ADA Curb Ramp New Construction Inspection Form (Perpendicular)

Nw 294th

23885.56

Nw 292nd

PERPENDICULAR RAMP (PR)

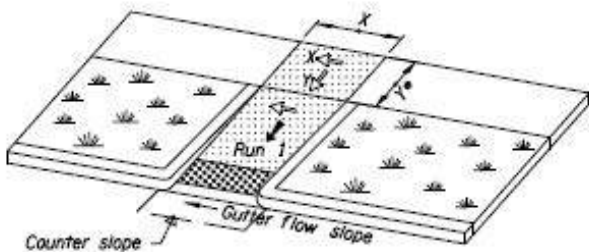
Slope Y

2.3

☒

IITD RR1 fails
